Addendum No. 3  
Regional Carrizo Project - Schertz Parkway Pump Station  
SAWS Job No. 10-8617  
SAWS Solicitation No. B-11-061-RA

### ADDENDUM NO. 3

March 26, 2012

1. The purpose of this addendum is to issue revisions to the plans and specifications for the Regional Carrizo Project - Schertz Parkway Pump Station (SAWS Job No. 10-8617; SAWS Solicitation No. B-11-061-RA). All questions received by the March 21, 2012 deadline are addressed in this addendum.

**S-104**  
Sheet 40 of 130

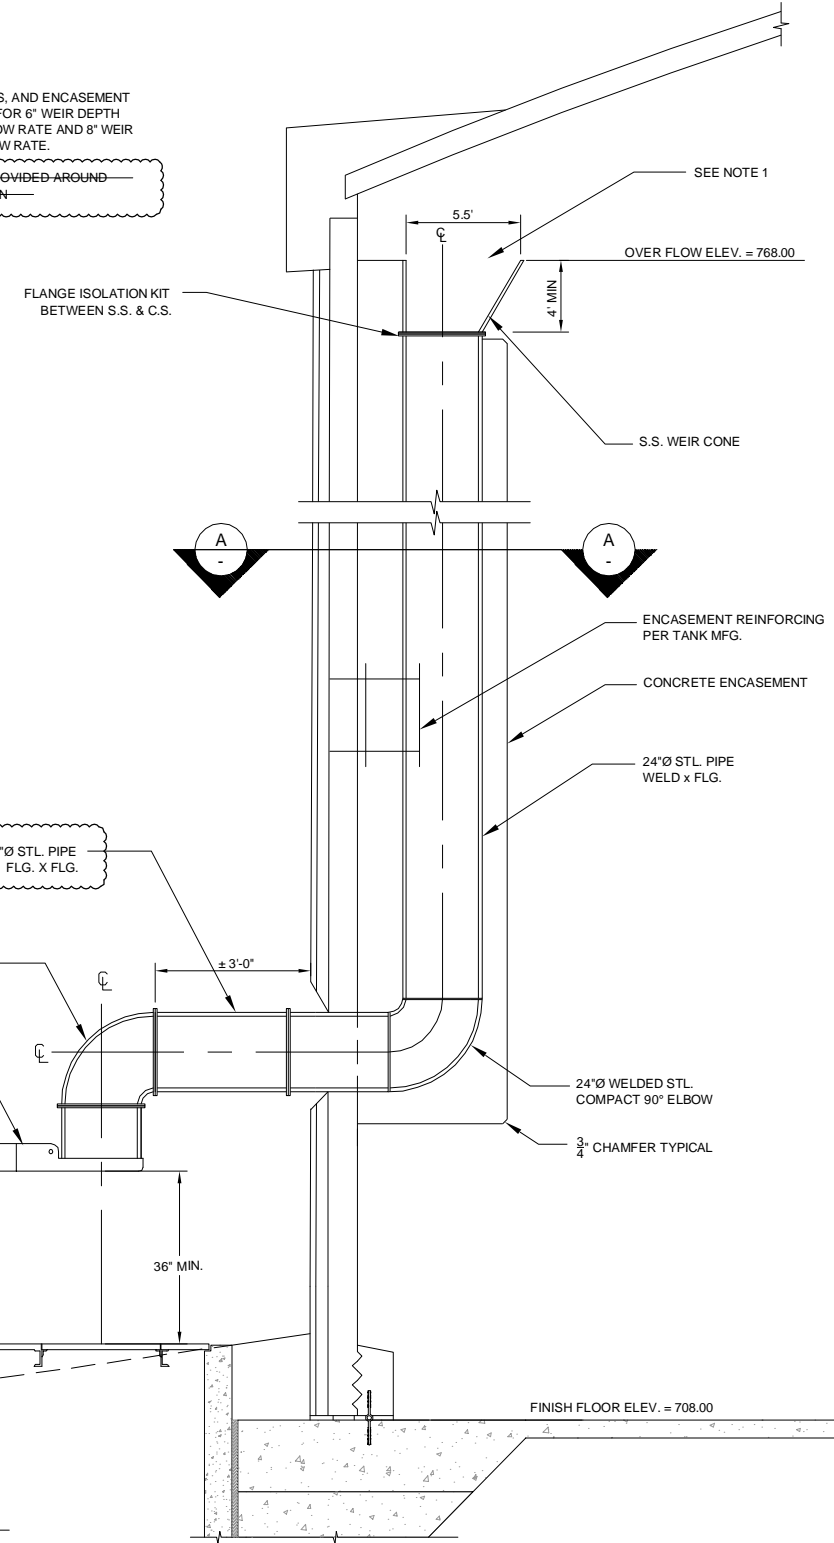
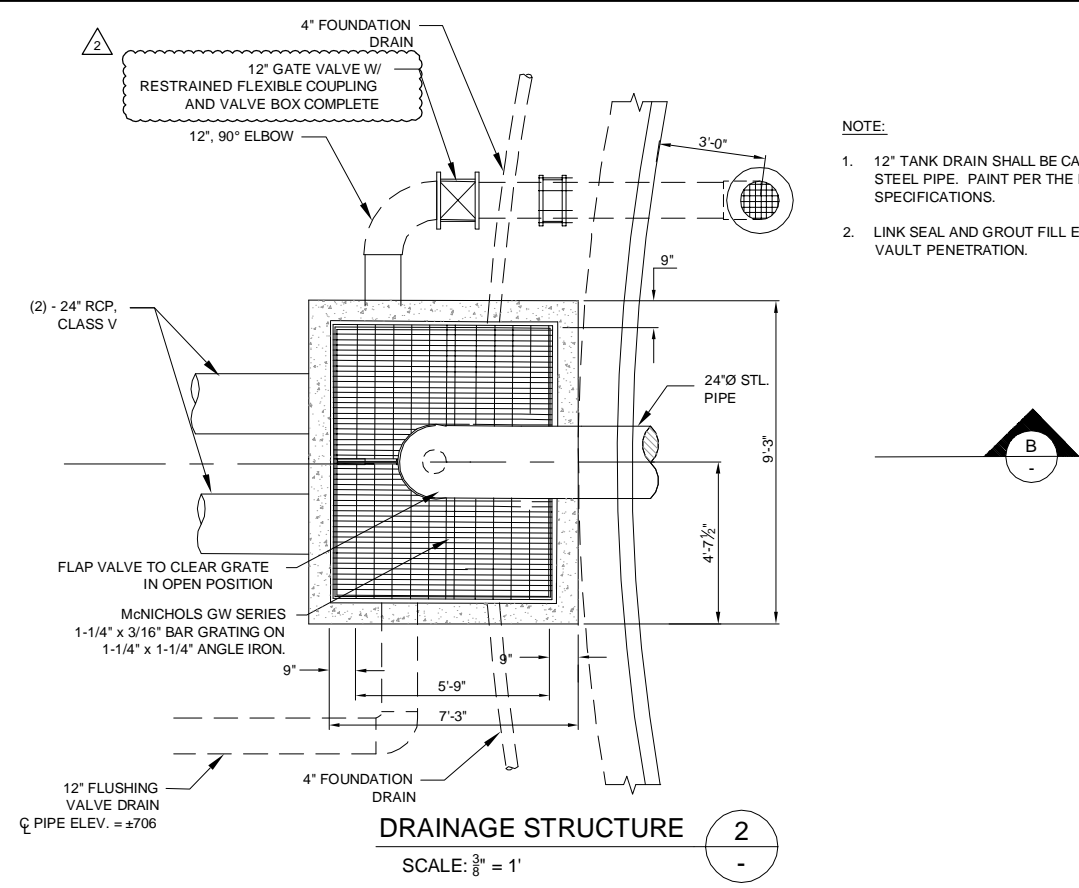
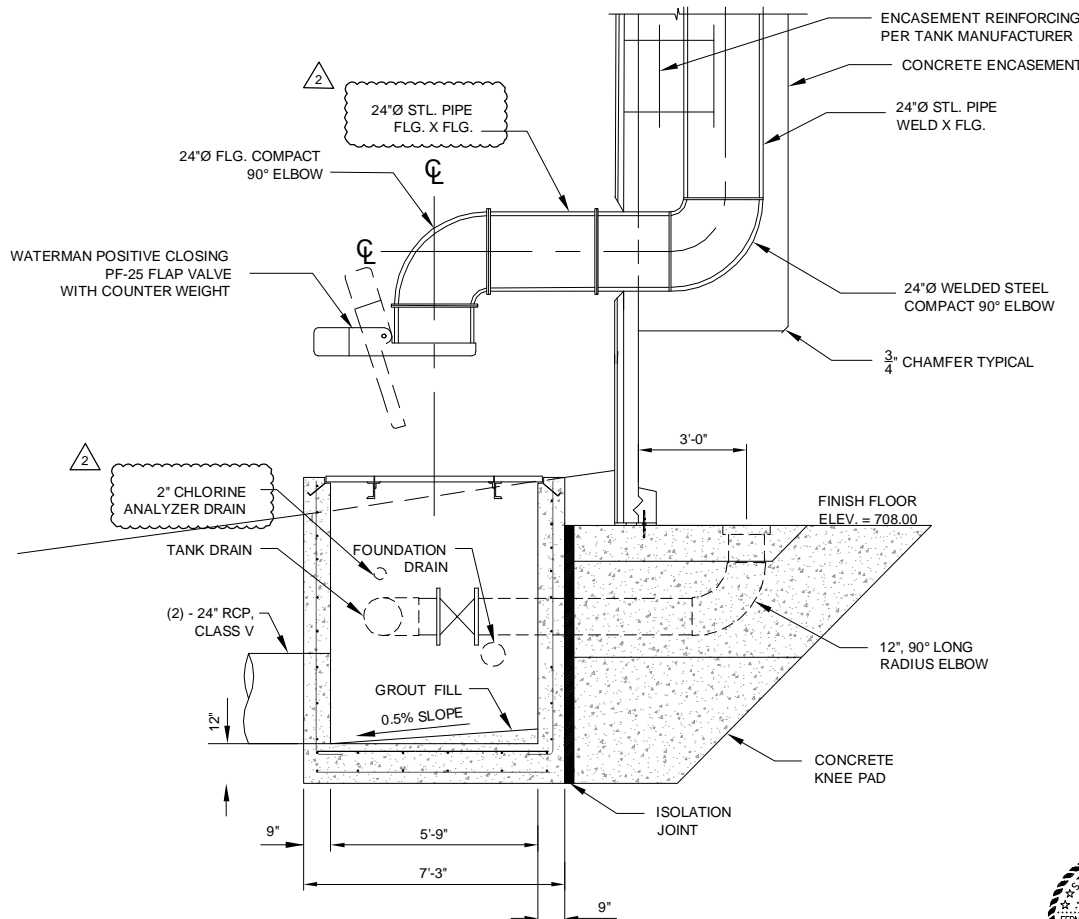
4. Sheet S-104, Detail 1, Note 2 – Please clarify if the cast stone ring around the wall penetration will be required for this project and if it is required, please provide a detail indicating dimensions and type of stone required.  
*Response: Omit Note 2, Detail 1 on Sheet S-104. Changes are indicated with revision clouds in the revised drawing included with Addendum No. 3.*

5. Sheet S-104, Detail 2 & B – Please confirm that a flexible coupling is required for the 12-inch drain line to accommodate the anticipated tank settlement.  
*Response: A flexible coupling is required between the tank and the 12-inch gate valve. Changes are indicated with revision clouds in the revised drawing included with Addendum No. 3.*

7. Sheet S-104 (40 of 130): Changes to Detail 1. Overflow and Detail 2. Drainage Structure are indicated with revision clouds in the revised drawing included with Addendum No. 3.
